ICC A117.1 STANDARD
THIRD PUBLIC REVIEW DRAFT
BACKGROUND REPORT

July 2, 2015

**ICC A117.1 Standard – Accessible and Usable Buildings and Facilities
Third Public Review Draft – Background Report
July 2, 2015**

Interpreter at side of stage

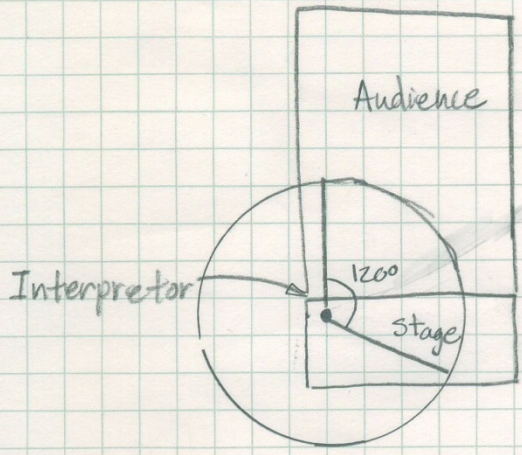
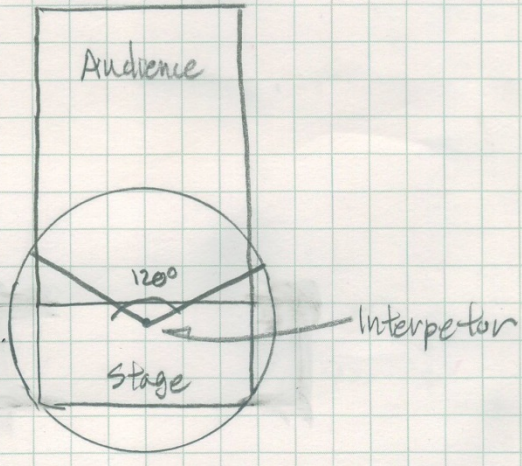
802.11.1 Area. A sign language interpreter station shall provide a level and clear floor of sufficient floor area necessary to enable a sign language interpreter with a minimum size of 24 inches (? mm) deep and 36 inches (? mm) wide that is located to providing a direct line of sight from to produce sign language legible from the seating area identified in Section 802.11.2 ~~and allow periodic interpreter shift changes to take place.~~

802.11.2 Location. Sign language interpreter stations shall be located so that seating within an arc ~~centered on from~~ the station and ~~subtending 120~~ measured to the left and right a minimum of 60 degrees maximum and not more than within 65 feet (19.8 m) horizontal distance from the station is provided with sightlines providing ~~unobstructed a~~

<p>view of the signers from top of their heads to their waists and to an arm's length to both sides of the signer sign language station from a height 36 inches (914 mm) to 72 inches (1829 mm) above the floor of the station, all as measured to the center of the station. The vertical viewing angle from the person in the seat to the interpreter station shall not exceed 30 degrees measures to the front and center of the floor of the sign language station.</p> <p>802.11.3 Illumination: The sign language interpreter station shall have lighting facilities capable of providing 10 foot-candles (108 lux) of illuminance while signing is underway be illuminated in compliance with 802.11.2 measured at the center of the floor of the sign language station at a height of 48 inches (1219 mm) above the floor. Illumination of the sign language interpreter station shall comply with the Recommended Maintained Illuminance Targets established for a "Transitional Sermon" by IES Handbook 10th Edition, Table 37.2.</p> <p>802.11.4 Backdrop. When a sign language interpreter station is located no greater less than 10 feet (3050 mm) in front of a permanent wall as measured tangent to the centerline of the arc described in Section 802.11.2 a portion of the wall measuring 69 inches (1755 mm) wide centered on behind the sign language interpreter station and to a height of 96 inches (2440 mm) high from the finish floor shall be considered as a backdrop. The surface treatment of the backdrop shall comply with Section 802.11.5 while sign language interpretation is being provided. The backdrop shall provide a flat, smooth surface with a monochromatic, low-luster finish treatment.</p> <p>Exception: The wall is not required to comply with Section 802.11.4 where a backdrop with a monochromatic, low-luster finish treatment is provided.</p>

<p>Comment Reason by Kim Paarlberg: 105.2.xx, and 802.11.3 - A handbook that includes recommendations should never be references in a standard that relies on mandatory requirements. This goes against all policies followed by the A117.1 for all other referenced standards.</p> <p>802.11.1 – The phrase “to produce sign language legible from the seating area identified” is replaced by “providing a direct line of sight from”. Whether or not sign language is legible is dependent on the eyesight of the viewer. This language is not clear or uniformly enforceable. The proposed language is consistent with language used in the assembly seating criteria and is more clearly understood.</p> <p>The phrase “and allow periodic interpreter shift changes to take place” is proposed to be struck because this is an operational issue and not clear. Does this mean that there has to be space for two people to exchange, or that there needs to be a place for the 2nd person to stand or sit out of the way? I have seen the 2nd interpreter sit next to the 1st interpreter or come from somewhere else – both options should be permissible.</p> <p>802.11.2 - The word subtend is defined in the dictionary as follows: In geometry, an angle subtended by an arc, line, or other curve is one whose two rays pass through the endpoints of the arc. The precise meaning varies with the context. For example, one may speak of the angle subtended by an arc of a circumference when the angle's vertex is a point on the circumference. A simple theorem of plane geometry states that arcs of equal lengths subtend equal angles in such a situation.</p> <p>Assuming this is the range for where the seats that have a good view of the interpreter are required, if an interpreter was standing in the middle of the stage, this might be doable. However, the most common place for an interpreter is at the side of the stage. This literally would require the viewing area to be behind them. See Figures. The maximum” could be read to indicate that the angle could be anything up to that range in width – including 0 degrees – which I don't think was the intent. ‘Unobstructed’ to 65 feet could be interpreted to not allow any columns in the room in that area. Thus the room we have our A117.1 meetings in would be in violation. Since an interpreter could be of any height, using the size of the interpreter for the viewing range is not consistent.</p>

Please see Comment Reason provided by Ms. Paarlberg. The committee approved this public comment as a welcome improvement and refinement of these provisions which will be new to the A117.1 standard.
